Technical Information

01 / 2003

911 GT3 Cup - 2003 Model

1. Relocation of the ventilation hose for the steering oil tank:

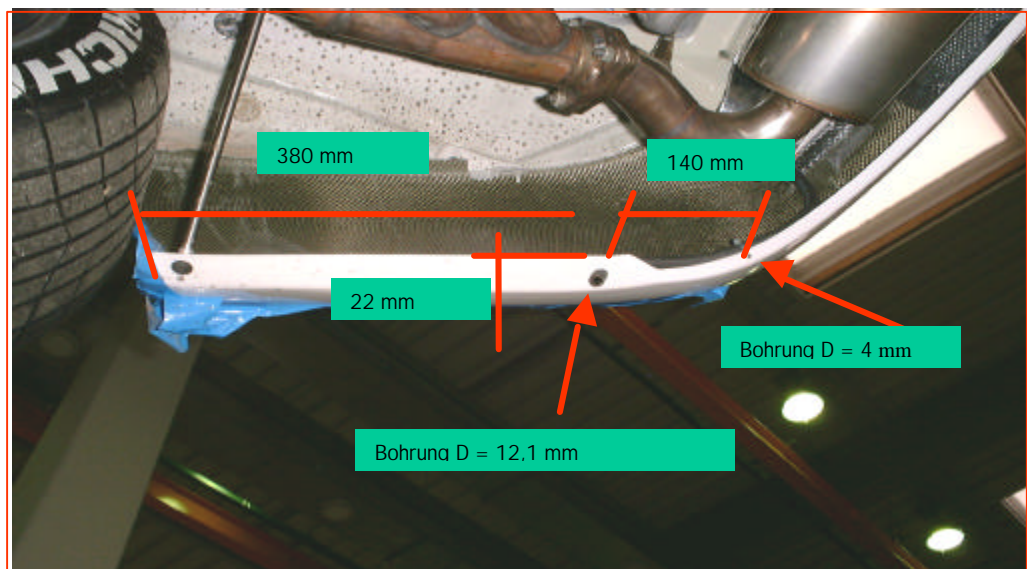
The ventilation hose for the steering oil tank turned out to be too short. Spilling oil might reach the exhaust manifold. We therefore recommend to mount the hose delivered to you according to the following mounting instructions:

Befestigung mit Kabelbinder
N.020.904.4

Entlüftungsschlauch
996.201.152.92

2. Relocation of the ABS combined line on front axle:

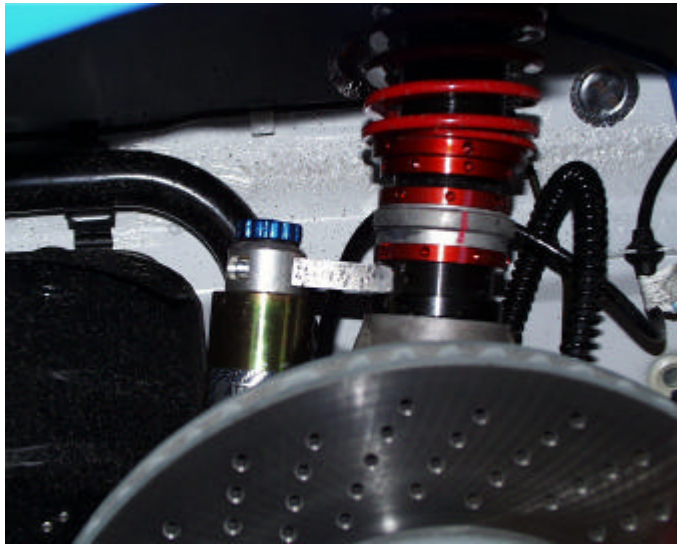
The new suspension struts as mounted in the 2003 MY 996 Cup car require the relocation of the ABS combined lines on the front axle. The lines must be installed behind the connecting piece between suspension strut and expansion tank (viewed from the position of the ABS sensor, see illustration).

4. Adjustment of shift gutter by using setting gauge:

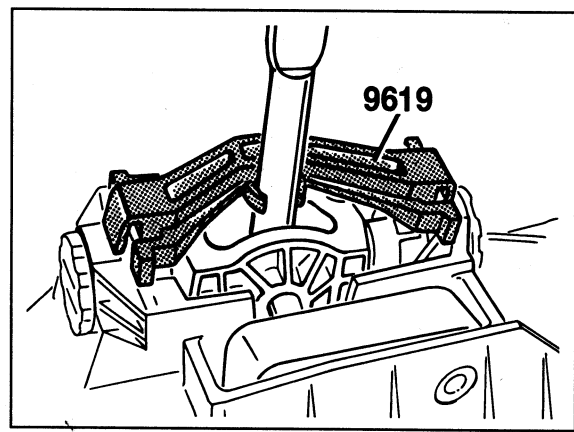
We recommend to check the shift gutter after the first roll-out by using the adjusting gauge delivered with the car and to adjust it if necessary.

- a. Turn gear-shift lever to neutral position and clip special tool No.9619 (see illustration) on gear-shift lever.
- b. Move the gauge downwards along the gearshift-lever tube.
- c. The setting gauge must engage without clearance (i.e. the gear-shift lever being immovable).

5. Mounting of front side windows:

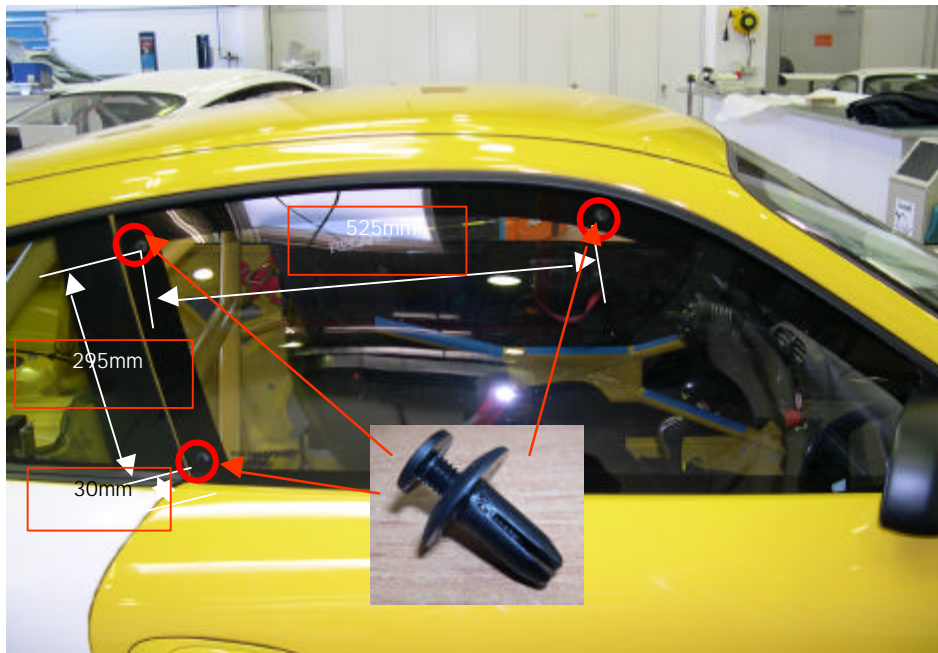
The bonding of side window / door frame may dissolve due to high air temperature and humidity. We recommend to additionally fix the front side windows mechanically. The part number of the clip fastener is 996.542.875.90.

Mechanical fixing

5.8mm bore for clip
